# Broome North Local Structure Plan No. 3

Addendum 1 – Amendment No. 1

Prepared for DevelopmentWA  
Prepared by Taylor Burrell Barnett  
July 2021

Figure 3 Modified Local Structure Plan (Inclusive of Amendment 1)

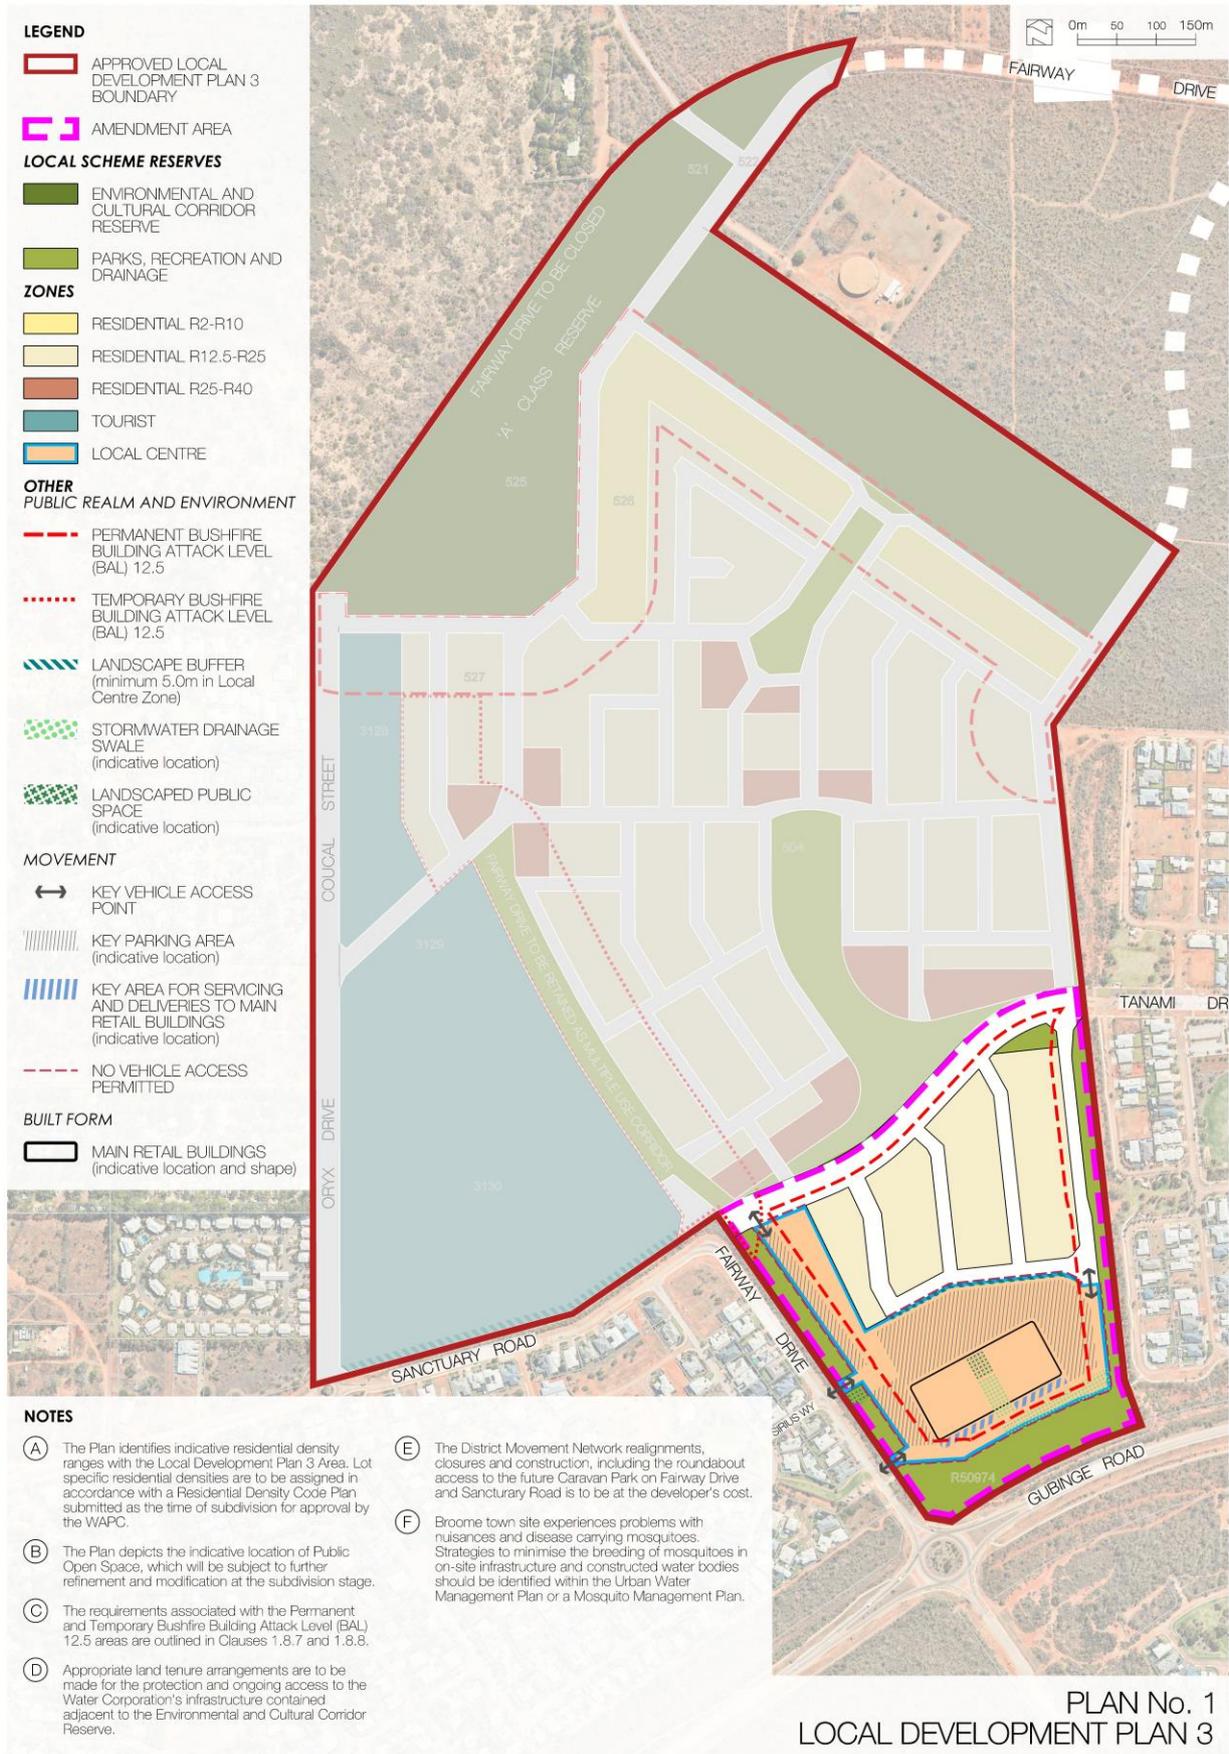
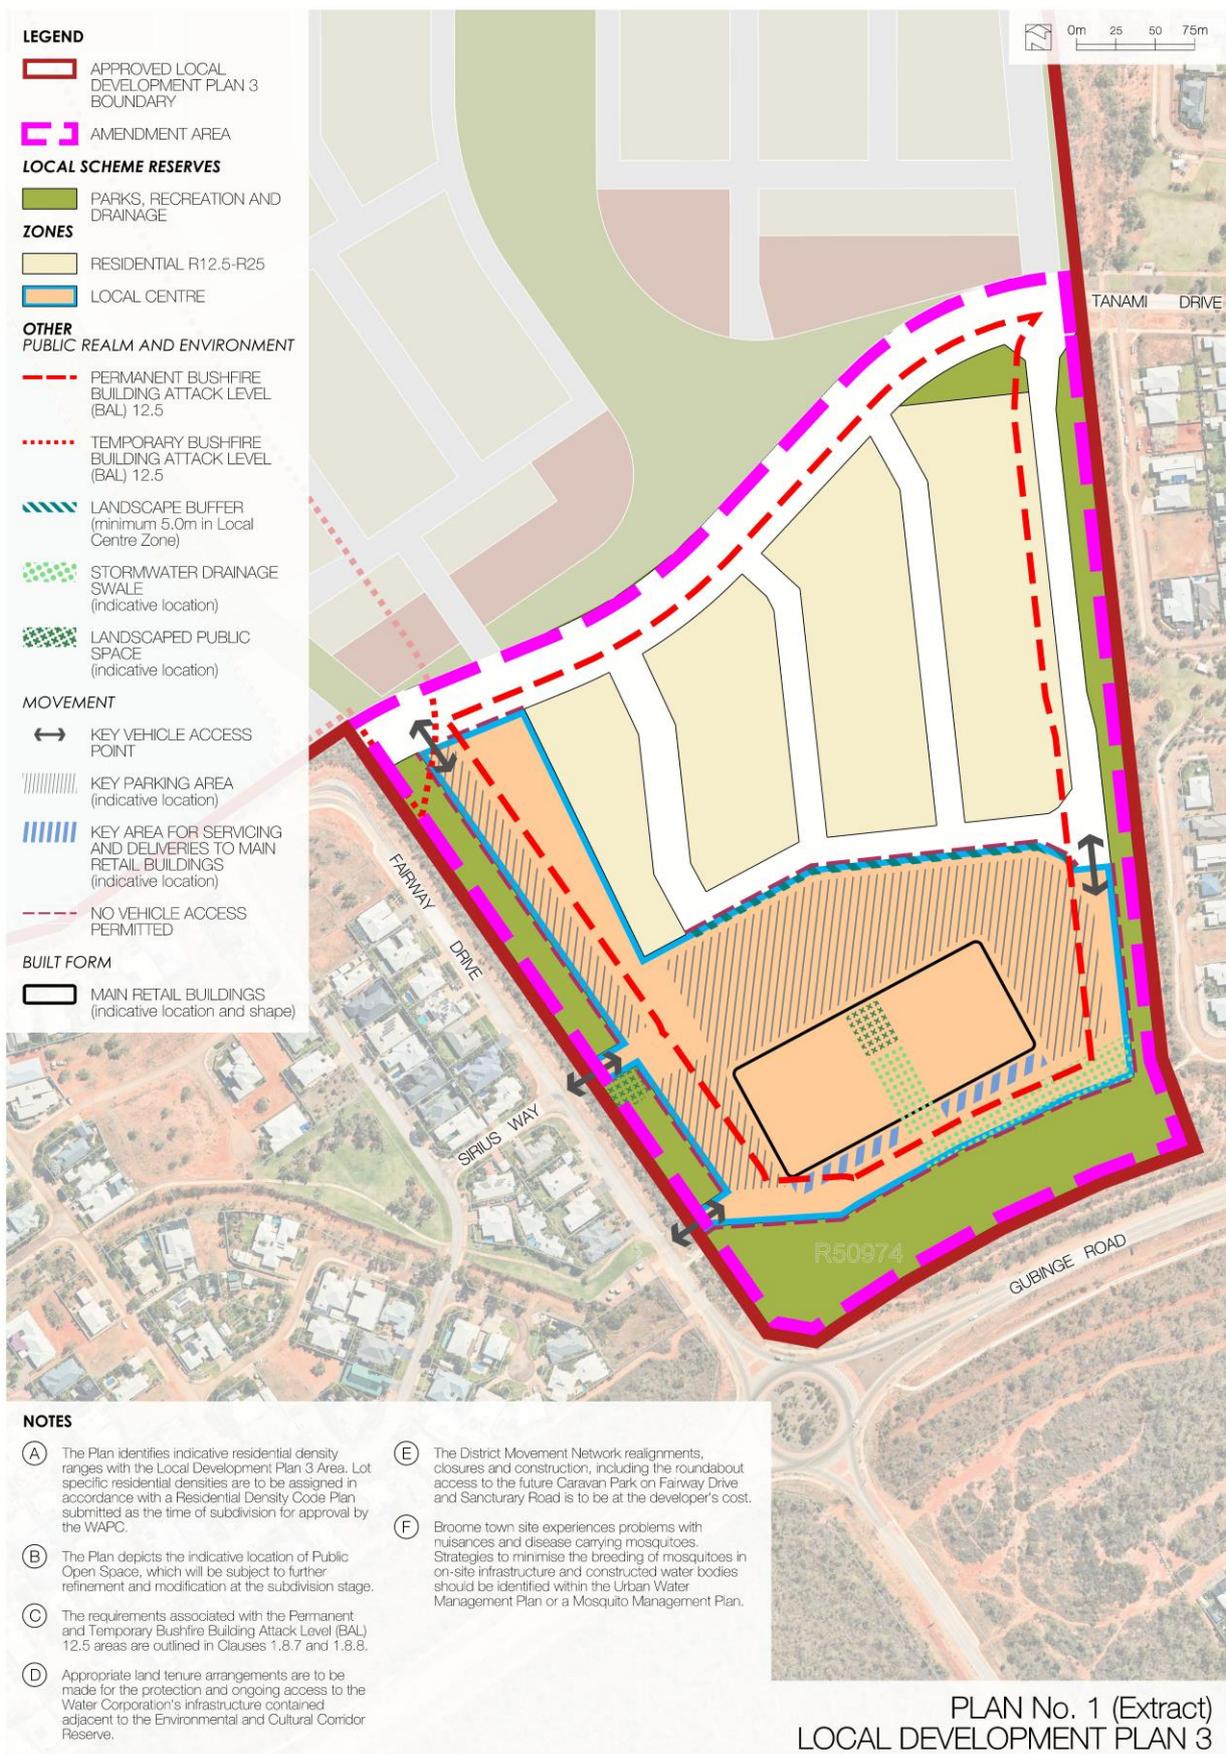
Amendment 1 to the approved Broome North Local Development Plan 3 (now referred to as a Local Structure Plan (LSP)) relates to the 20.35ha portion of Lot 504 south of Tanami Drive (refer **Figure 1**). **Figure 2** details the existing approved LSP, **Figure 3** illustrates the proposed modifications subject to Amendment 1, and **Figure 4** provides an extract of amendment area of the Modified LSP.

The extent of residential land south of Tanami Drive has been reconfigured in the modified LSP to accommodate the District Centre. The modified LSP includes a total of 5.57 ha of residential land south of Tanami Drive, which is identified as R12.5-R25, replacing the R12.5-R25 and R25-R40 densities identified in the same location in the approved LSP. A revised Residential Density Code has been prepared and included in **Figure 5**.

**Figure 3 Removal/relocation of local centre**

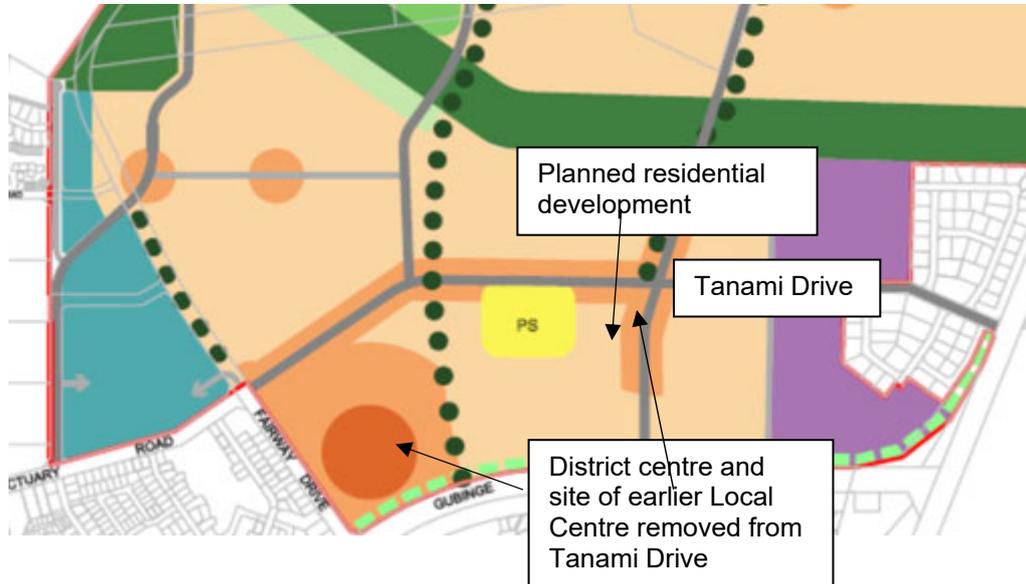
To ensure consistency with the Shire's Local Commercial Strategy, the local centre in the LDP has been removed and a district centre has been added to LDP3. Figure 3 and Figure 5 refer.

**Figure 9 Centre access**

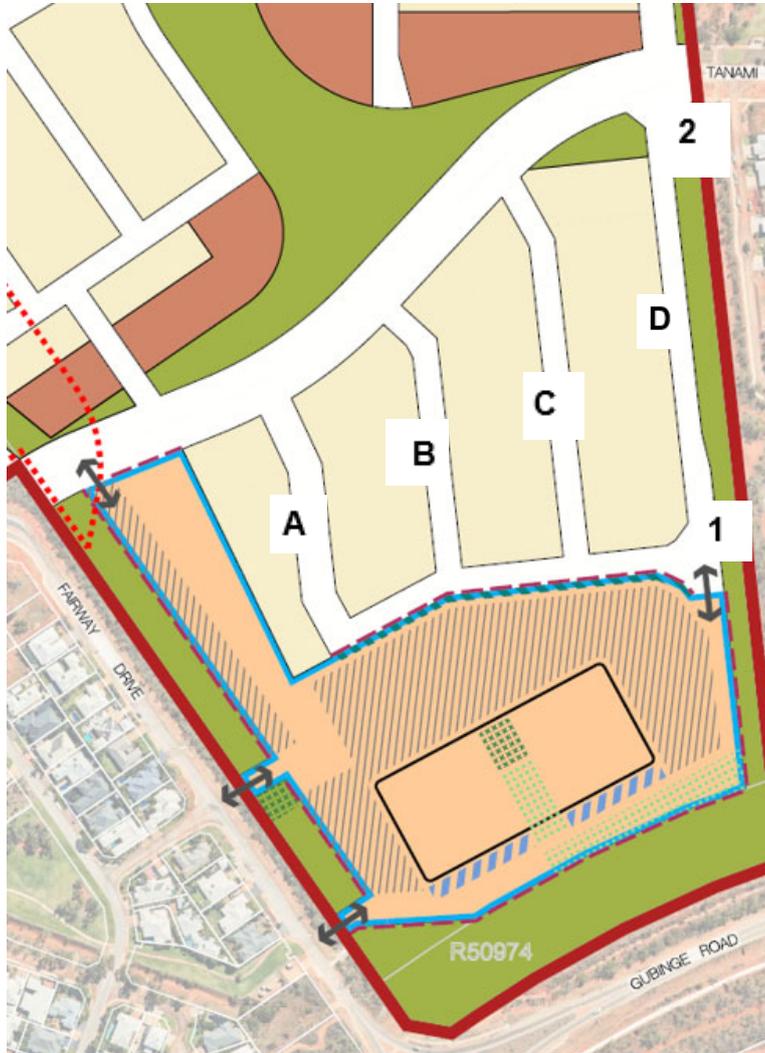
The Centre will draw traffic from the surrounding northern development. Four accesses are proposed to the Centre as indicated in Figure 9. These will distribute traffic generated by the Centre via Tanami Drive and Fairway Drive. A roundabout is proposed at the north east corner of the Centre site (1) and will be designed with a tight radius/geometry to the west to discourage truck movement. The roundabout at the north-south road/Tanami Drive intersection (2) will facilitate good access to the Centre reducing the need to use other residential streets. The three north-south roads (A,B,C) could have traffic calming measures to further discourage traffic accessing the Centre via these roads, however it is considered unlikely to be necessary as there is no direct access to the Centre from these roads.

The main north-south residential road (D) could also be traffic calmed to reinforce its secondary Centre access status. This road is forecast to carry <3,000vpd on full development including Centre and residential traffic. It is proposed as a 15m reserve incorporating a 7m carriageway, 6m verge on the west side and 2m verge on the eastern side. Table 5 indicates the road will operate at a good level of service, A. Liveable Neighbourhoods indicates a 7m Carriageway with anticipated traffic volumes of 3,000vpd – Access Street C.
